IDAP REPORT

Property:	2 Chiswick Street STRATHFIELD SOUTH DA 2020/197
Proposal:	Construction of a double storey dwelling and associated landscape works.
Applicant:	Wisdom Homes
Owner:	J. Parra & K. Parra
Date of lodgement:	28 October 2020
Notification period:	11 November 2020 to 25 November 2020
Submissions received:	One (1) submission received.
Assessment officer:	N Doughty
Estimated cost of works:	\$656,079.00
Zoning:	R2-Low Density Residential - SLEP 2012
Heritage:	The subject site adjoins local heritage item No. I1223.
Flood affected:	No
Is a Clause 4.6 Variation Proposed:	No
RECOMMENDATION OF OFFICER:	APPROVAL

Figure 2: Front (north) elevation

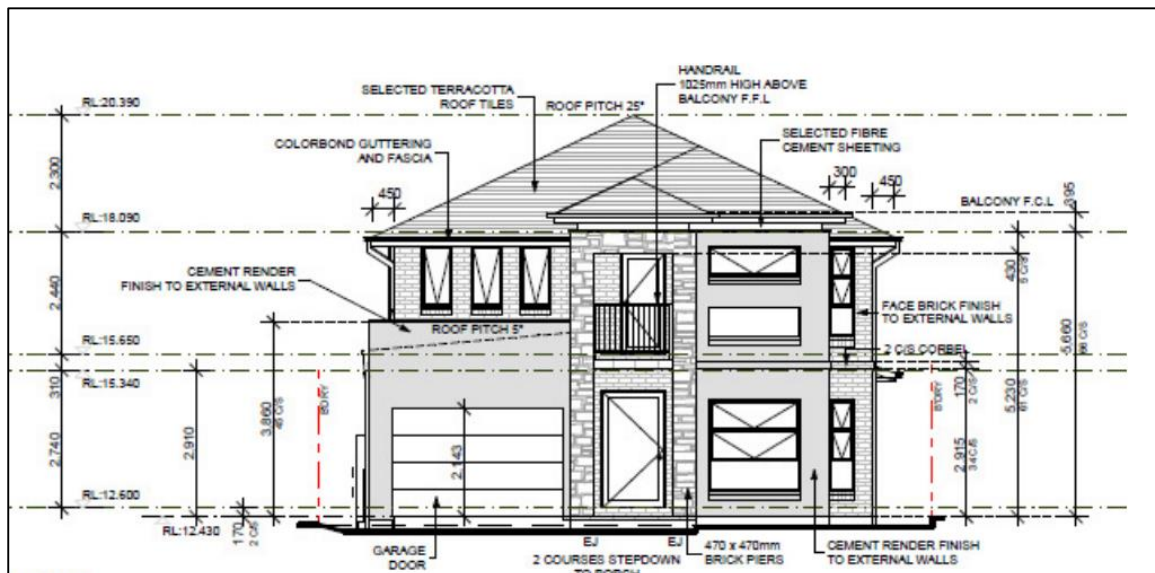
The front building façade includes a two (2) storey portico with an associated porch protruding 1m forward of the front building façade. The two (2) storey portico is vertically broken by the first floor balcony and is proportional to the building envelope.

The front porch and portico element is setback 5.49m and the main portion of the front building façade is setback 6.5m from the front property boundary. Whilst the front setback is contrary to the 9m minimum front setback requirement, it is no less than the front setback of the existing dwelling and it is consistent with the prevailing front setbacks along the southern side of Chiswick Street. Accordingly, the front setback will not conflict with the existing streetscape and is acceptable in this instance.
